ADMINISTRATIVE SHORT PLAT REPORT & DECISION

REPORT DATE:	April 26, 2012		
Project Name:	Key Plaza Short Plat		
Owner:	Amber Properties, LLC PO Box 3016 Renton, WA 98056		
Applicant:	David Cayton Core Design Inc. 14711 NE 298 th Place, #101 Bellevue, WA 98007		
Contact:	Jay Bales Amber Properties, LLC PO Box 3015 Renton, WA 98056		
File Number:	LUA12-012, SHPL-A		
Project Manager:	Gerald Wasser, Associate Planner		
Project Summary:	Application requesting Administrative Short Plat review in order to subdivide an existing 1.4 acre property into 2 lots ranging in size from 29,856 s.f. to 31,243 s.f. A commercial structure (Key Bank) occupies the north portion of the site (future Lot 1). The southern portion of the property (future Lot 2) is presently vacant. The site is zoned Commercial Arterial (CA). Access would be from NE 4th Street and Bremerton Ave NE. There are no critical areas located on the site. No grading is proposed and trees will not be removed as a result of the short plat. Perimeter landscaping is proposed for new Lot 2. A street modification request was previously approved (Exhibit 6) to allow the retention of street improvements that were recently constructed includin

EXHIBIT 2

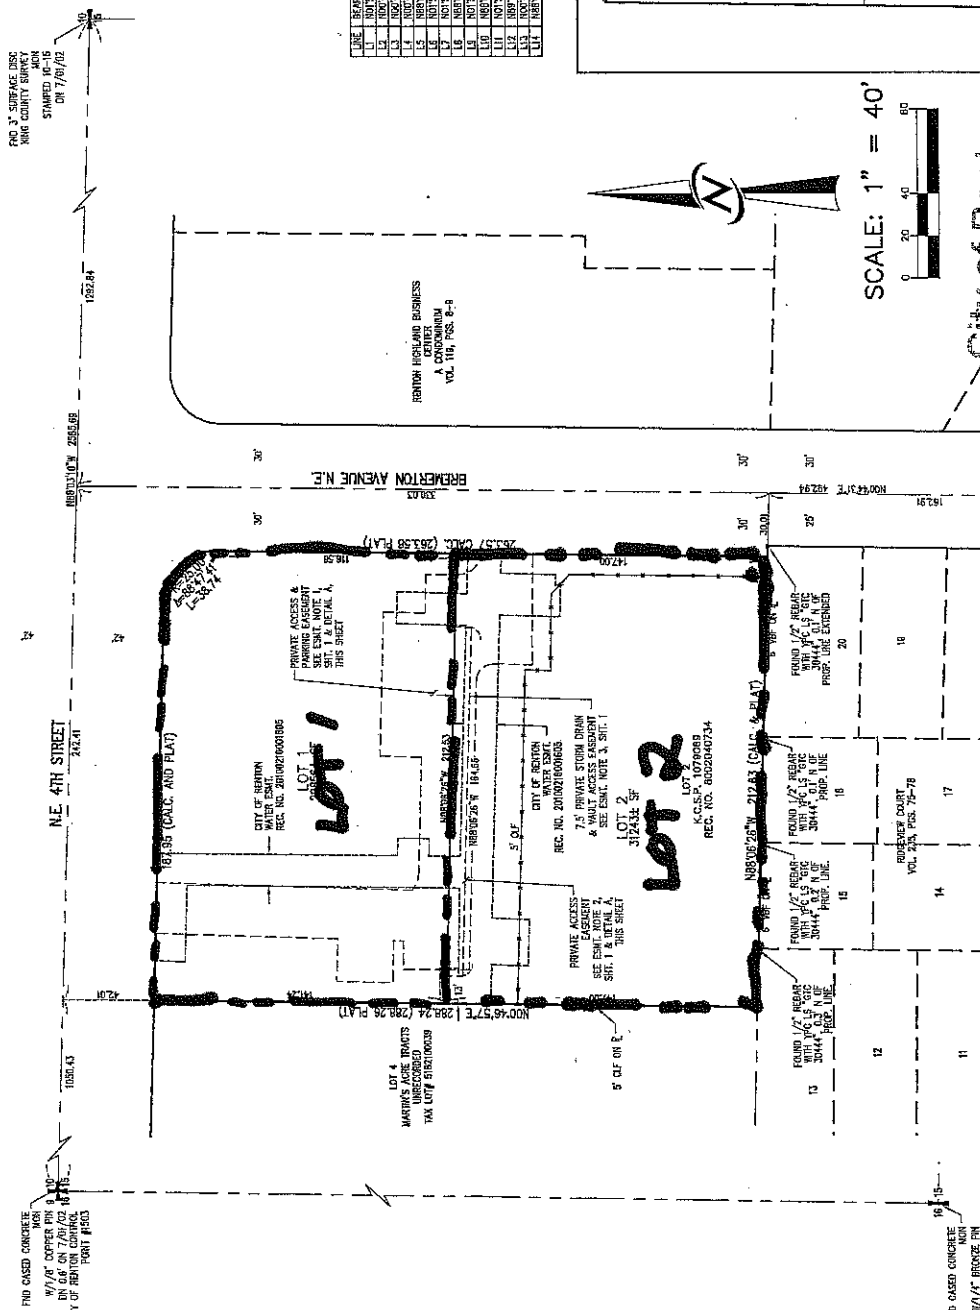
1. Note the City of Renton land use action number and land record number, LUA-12-012-SHPL-A and LND-20-0570, respectively, on the final short plat submittal. The type size used for the land record number should be smaller than that used for the land use action number.

2. Change the "DEDICATION/CERTIFICATION" title to OWNER'S DEDICATION. The language shown is for a Plat and includes several paragraphs not relevant to the subject.

3. Provide lot closure calculations.
4. Indicate what has been, or is to be, set at the corners of the proposed lots.
5. Note the lot addresses pursuant to the attached on the short plat drawing.

6. The City of Renton "APPROVALS" block is signed by the City of Renton Administrator, Department of Public Works.
7. The found date juxtaposed to the monument locations does not agree with the statement relative to same in SURVEYOR'S NOTES number 2.

8. Provide a bearing distance for the north half of the west line of Section 15; between the City of Renton Survey Control Network monuments shown. The geometry will be checked when the ties to the Survey Control Network is shown on the short plat. Please note that the distance shown for L2 appears to be erroneous.
